HYBRID NUCLEAR EMULSION - 15' BUBBLE CHAMBER
EXPERIMENT TO STUDY NEUTRINO PRODUCED
SHORT LIVED PARTICLES

HYBRID NUCLEAR EMULSION - 15' BUBBLE CHAMBER
EXPERIMENT TO STUDY NEUTRINO PRODUCED
SHORT LIVED PARTICLES

MARCH 2, 1977

In responding to the questions raised by the representatives of the PAC as a result of the proposal presentation made on February 11, 1977, we have prepared the following addendum to our Proposal 534:

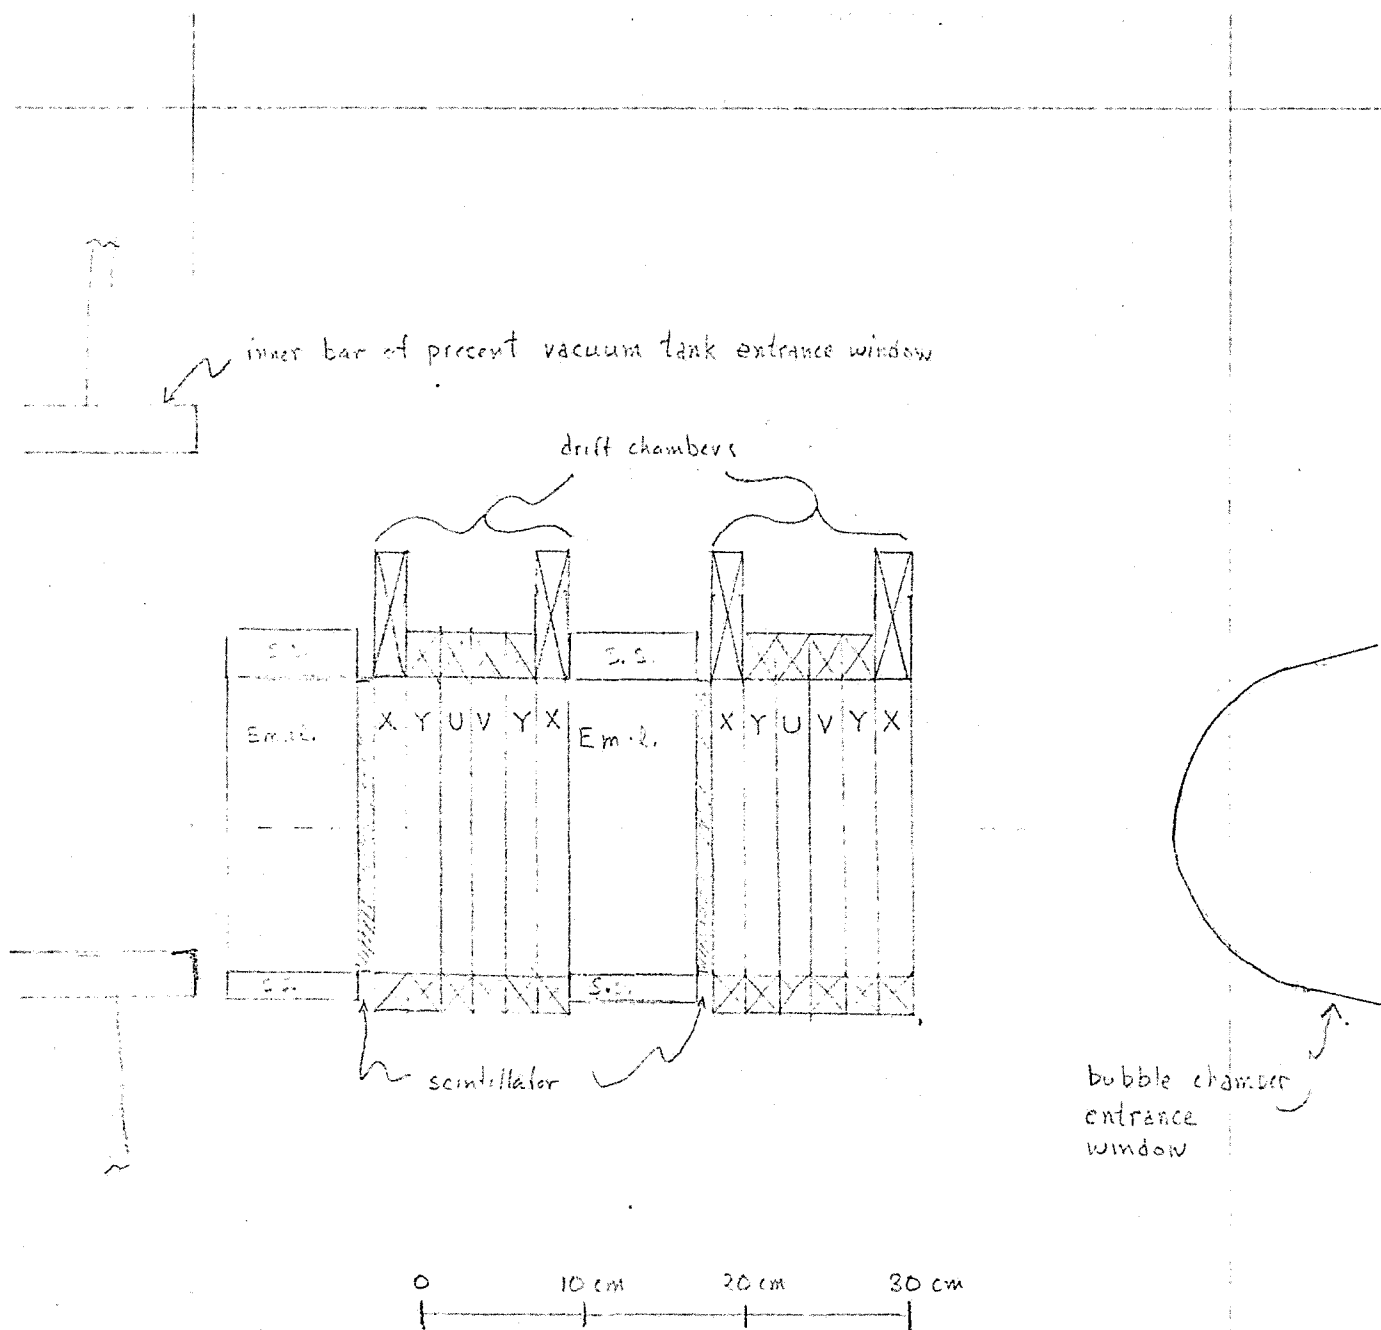
The current design of the drift chamber/emulsion package is shown in Figs. 1 thru 3. We are planning to support, insert, and lower the apparatus from outside of the proposed well in the 15' vacuum tank. A sketch of this apparatus is shown in Fig. 4. What is not shown are details of the well, extending the vacuum window into the present vacuum area, which we would expect Fermilab to design and construct. What we now can state with some certainty is that we would require a space 14" high, extending 2" below the lower edge of the present window and at least 17" deep, but any more would be greatly appreciated.

In preparing this more detailed design, we have stressed the importance of placing the emulsion as close to the nose window as possible, and thus we essentially have been forced to put the entire apparatus inside the present entrance window in order to clear the entrance window support structure. (We would prefer to have a larger, centered window, but assume that a modification of that scale is out of the question.)

- elimination of an emulsion module, cutting event rates (as well as most equipment costs) by $\frac{2}{3}$;
- reduction in the distance between the

emulsion stacks from 20 to 13 cm, which will degrade the momentum measurement by about a factor of 2;

- cutting down the number of drift chambers following each emulsion from 8 to 6, but employing an XYUVYX arrangement with small angle stereo which should still resolve left-right and multiple track ambiguities;
- replacement of the MWPC planes with scintillators to gain space at the expense of light pipes and large phototube shields on the outside.
- changes in the mechanical design of the emulsion stack clamps (Fig. 3).

FIG 3

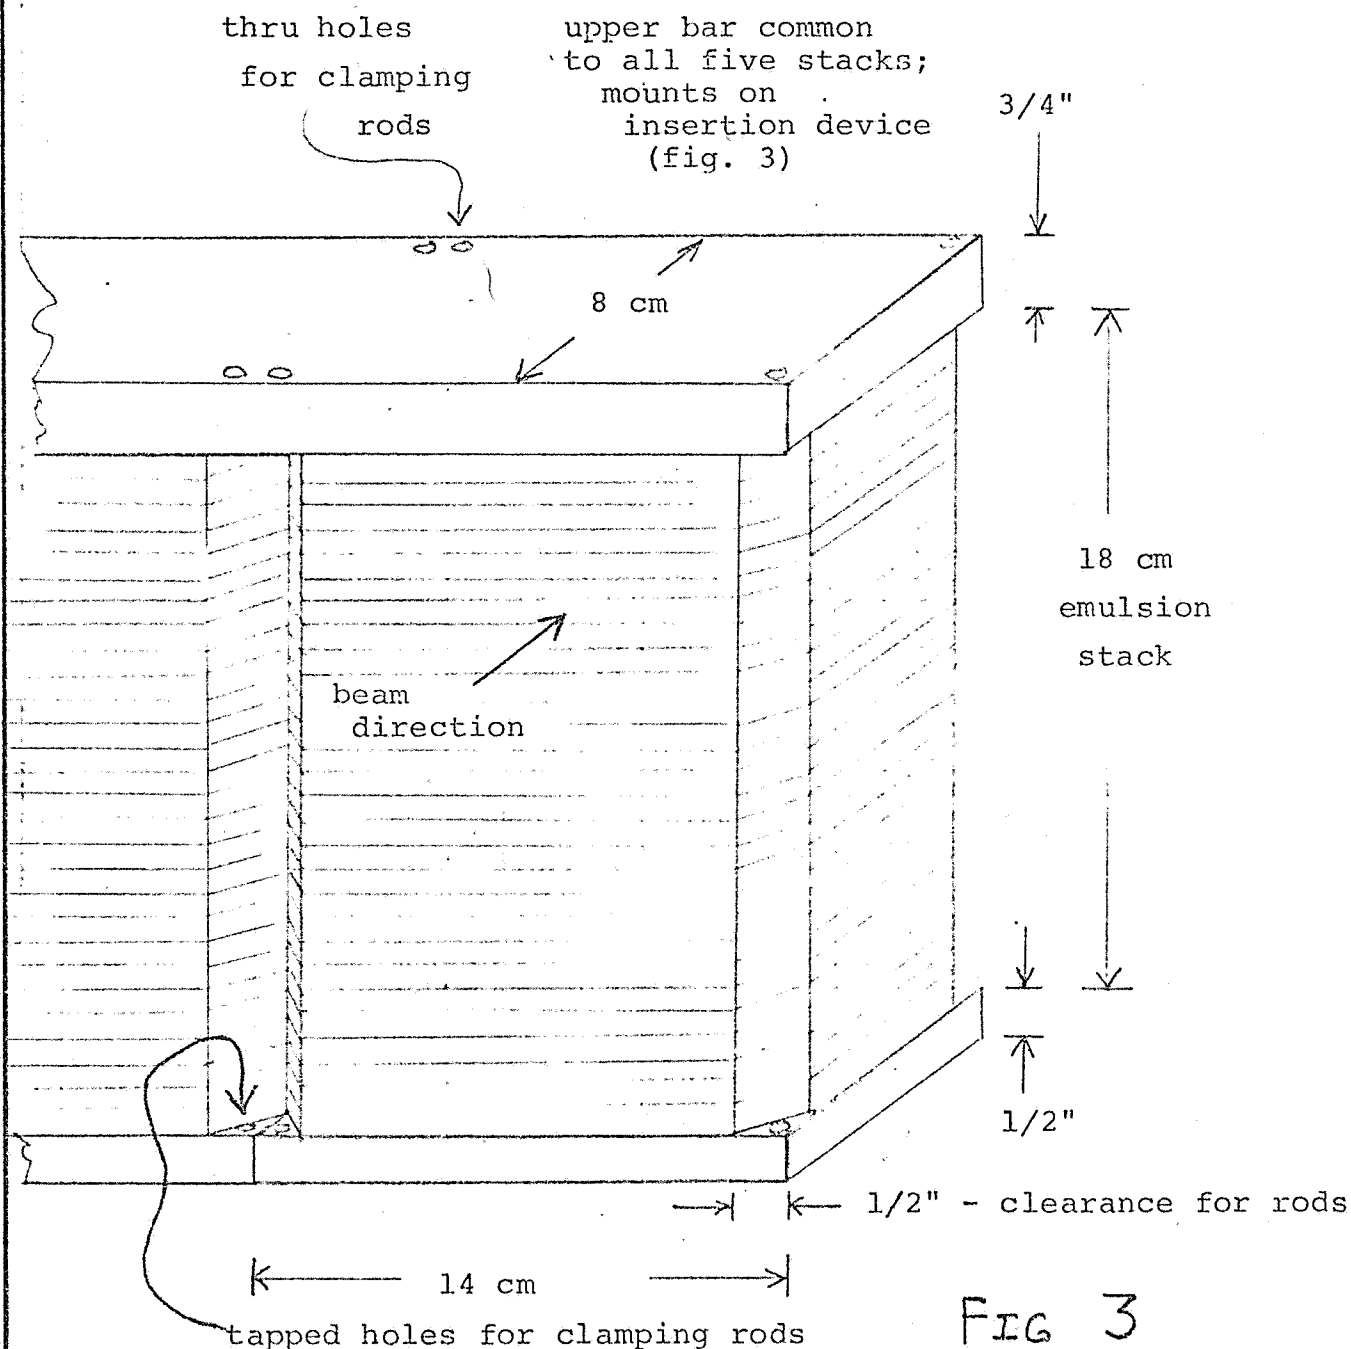
One emulsion stack is shown; five stacks side-by-side form one emulsion module. The clamping members are stainless steel and are held together by 1/4" rods (not shown). The entire module measures 70 cm x 8 cm x 21 cm.
